# Metro78 Waste Removal Unaddressed Serious Safety Concerns

A Path Less Travelled Consulting Inc. prepared this document. We were engaged by nearby residents of the Metro78 proposal to review the Transportation Impact Assessment and related concerns.

We prepared it to more clearly document our serious safety concerns with the Metro78 Waste Removal that the City administration accepted.

The following page is a diagram showing the south building as the related land requirements for the truck sweep.

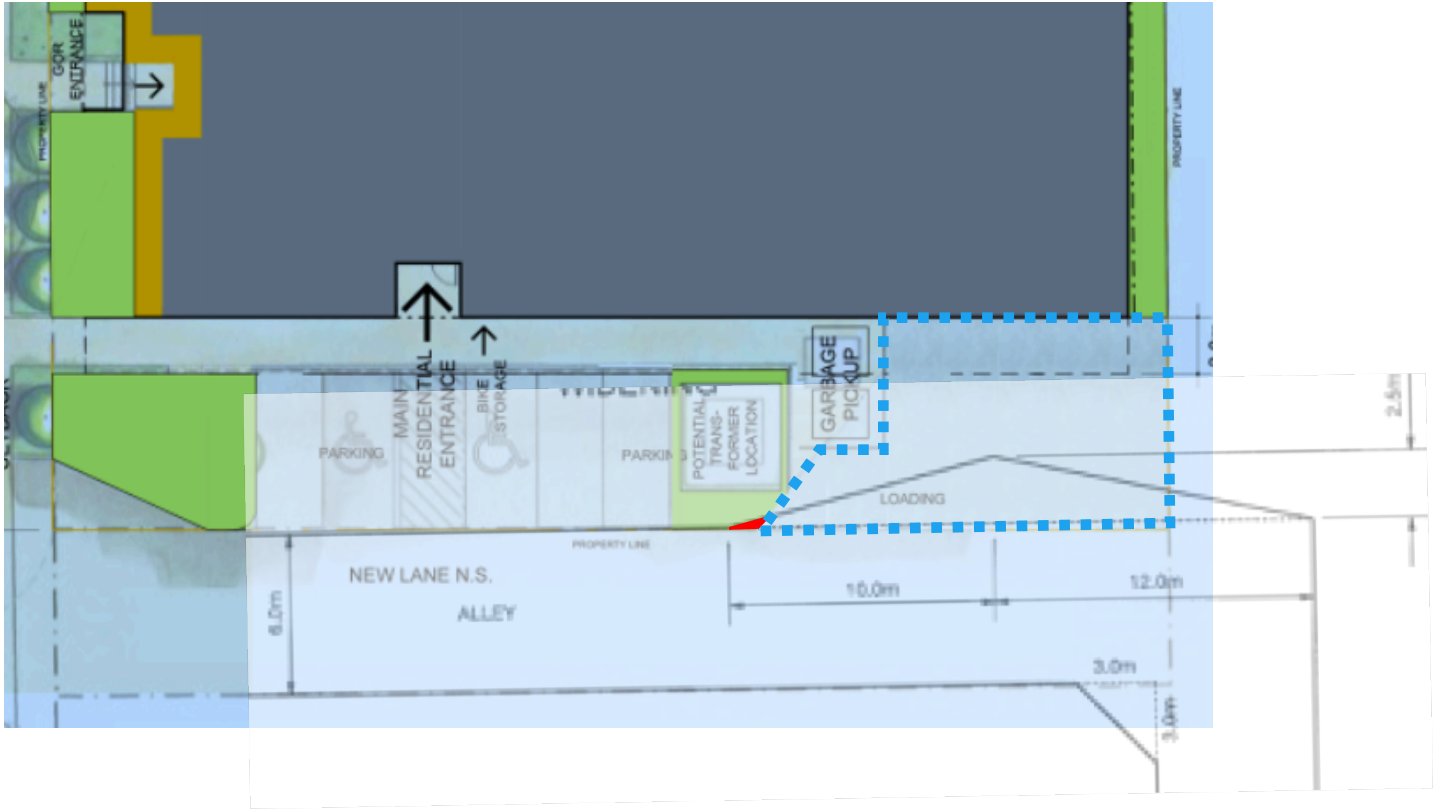
The City accepted the developer's proposal to use the truck loading area for the truck sweep. The blue dotted line shows the loading area.

We overlapped the City's standard drawing #3030 onto the developer's plans. This allows us to understand the approximate area required for the trucks. However, because the existing east-west lane is 5m wide, but the City stand assumes a 6m wide alley, the area required for the turn will be

larger – possibly significantly so given the flat angles involved in these kinds of turns.

This will need to be checked using vehicle turning templates and software, which the developer's engineer did in the TIA for a fire truck situation. We do not know why the City did not require a similar truck turning template for the waste trucks in the TIA.

The diagram shows the area required for the Alternative Widening from the Metro78 property – it is both the red as well as orange portions. The orange portion is also part of the loading zone. However, the red is not part of the loading zone. In addition, because of the narrower east-west lane, the truck will need to start its turn earlier than shown and swing wider. This will encroach further into the Metro78 property and may encroach into the transformer.

This means the City standard was not enforced by City staff. It also means waste trucks cannot turn without backing.

The following page is a diagram showing the north building as the related land requirements for the truck sweep.

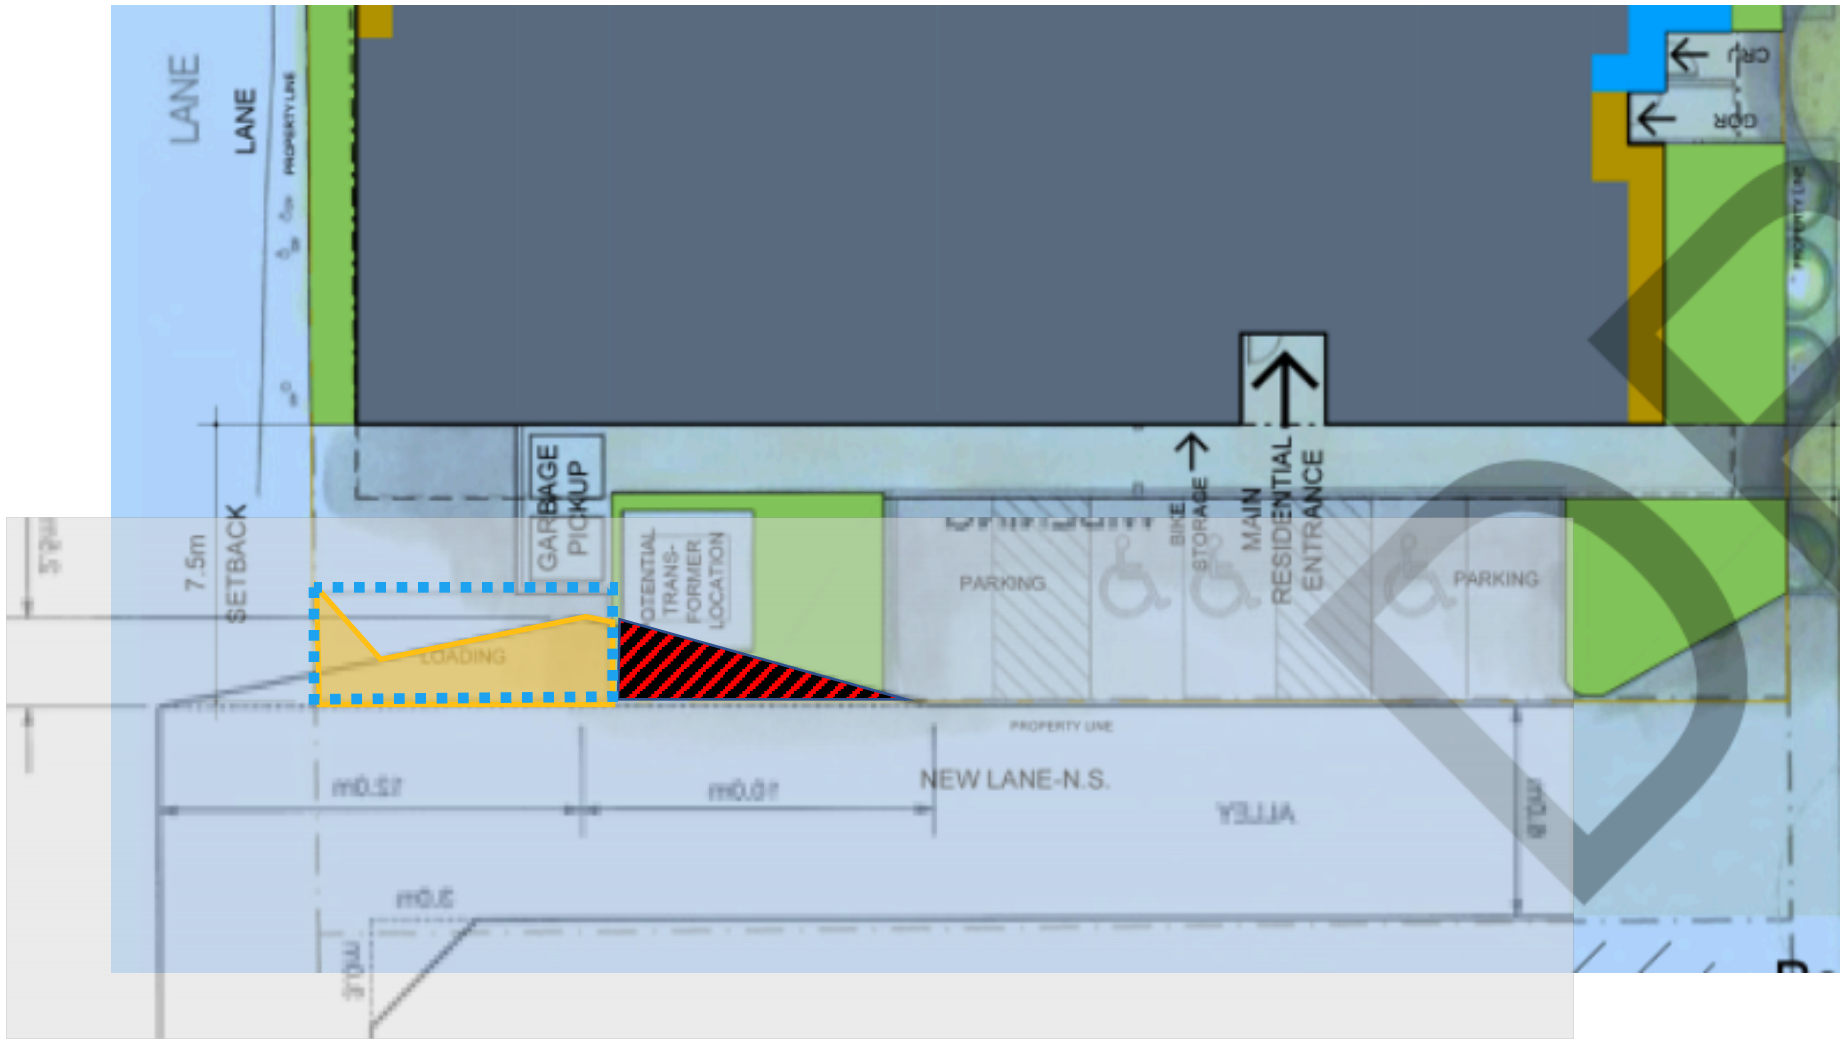
The City accepted the developer's proposal to use the truck loading area for the truck sweep. The blue dotted line shows the loading area.

We overlapped the City' standard drawing #3030 onto the developer's plans. The diagram shows the area required for the Alternative Widening – it is both the red and black striping as well as orange portions. The orange portion is also part of the loading zone and includes both types of corner cuts from standard drawing 3030 because both turns must be accommodated. However, the red and black striping is not part

of the loading zone. The north building has an additional problem - the area required for the waste truck turn infringes on the building transformer.

And as with the south building, the east-west lane is 5m wide, not the assumed 6m wide in the City standard. Thus the sweep for the truck will need to start sooner and swing wider into the Metro78 property.

This means the City standard was not enforced by City staff. It also means the transformer must be relocated, which we found challenging in past negotiations with the developer, and waste trucks cannot turn without backing.
